**Our Case Number:** ABP-317121-23

**Re:** BusConnects Swords to City Centre Bus Corridor Scheme  
Swords to Dublin City Centre

**Re: BusConnects Swords to Dublin City Centre Core Bus Corridor Scheme**

**An Bord Pleanála Ref. No. 317121**

Figure 1: Extract from General Arrangement Drumcondra drawing

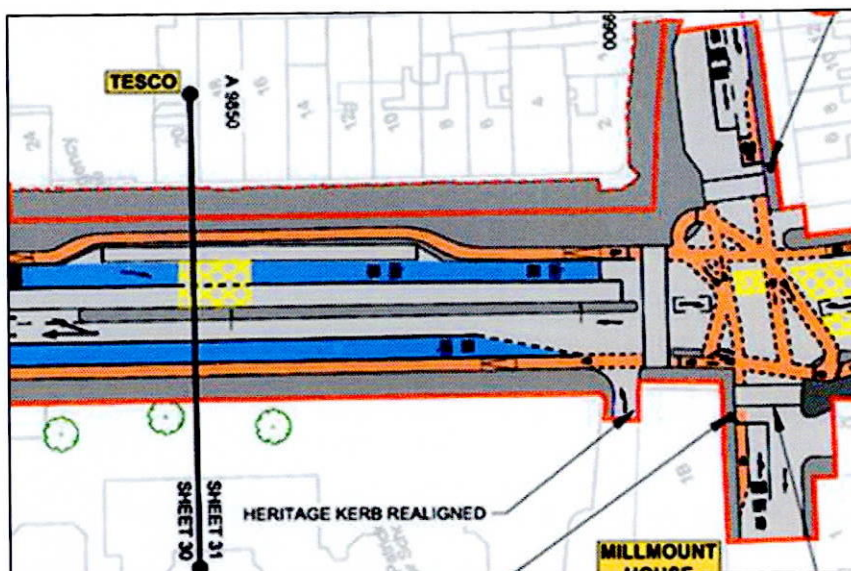
During the Preferred Route Option stage of the public consultation, our client requested that a portion of the parking proposed outside the store situated on the Drumcondra Road be designated as a loading bay. It appears from the scheme submitted to ABP (see Figure 1); the space has been extended without any designation for loading bay facilities. Given the volume of commercial premises in the vicinity, it is requested that a dedicated loading bay be provided at this location.

Furthermore, we would request consideration is given at detailed design stage for the materials/treatments between the identified space ('Loading Bay') and cycle track to facilitate movement of stock and goods to premises. Our client would like to express their preference for no raised kerbs between the space ('Loading Bay') and cycle track as this can act as an impediment and, where possible, the provision of a buffer zone between the loading bay and the cycle track, that could accommodate delivery cages that are 846mm. Additionally, we would like to suggest bollards/warning signs are erected for cyclist safety given the change in cycle track direction.
